CITY OF ADELAIDE COUNCIL ASSESSMENT PANEL ON 28/3/2022

Item No	3.1
Address	266 Melbourne Street, North Adelaide SA 5006
Proposal	Demolish existing building and construct four level residential flat building containing 15 apartments with ground level car parking, DA/174/2021 [DA], EP)
Applicant	THE SUNSHINE LIFE P/L
Relevant Development Plan	30 April 2020
Lodgement Date	17 March 2021
Zone / Policy Area	Mixed Use (Melbourne West) Zone
Public Notification	Category 2
Application Type	Application Assessed on Merit
Delegations Policy	Unresolved Representations
Recommendation	Development Plan Consent Be GRANTED

Figure 1

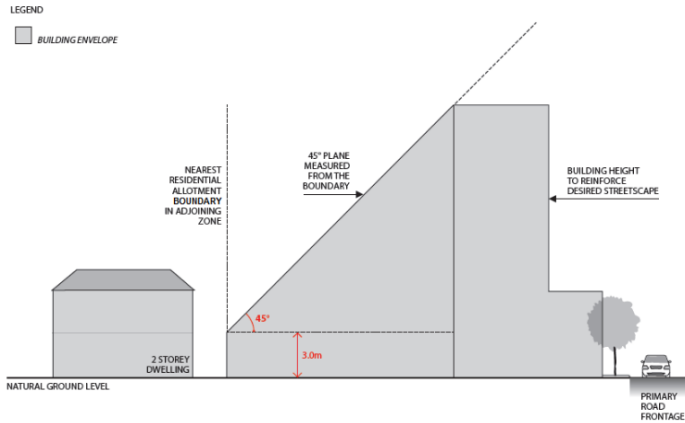
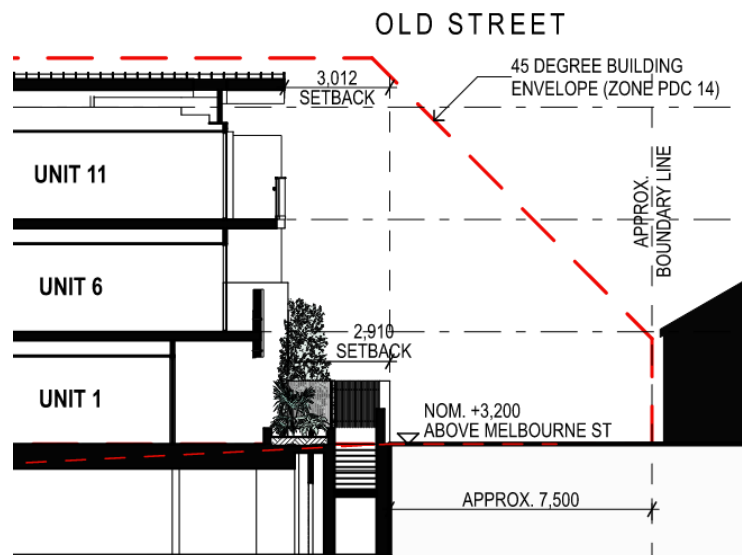
- The setback at ground level is similar to existing nearby developments.
- The setback of the upper levels, at 5 metres is below the 6-10 metres desired.
- The setback on Old Street complies with Figure 1 below (Figure 1 is an excerpt from the Development Plan).
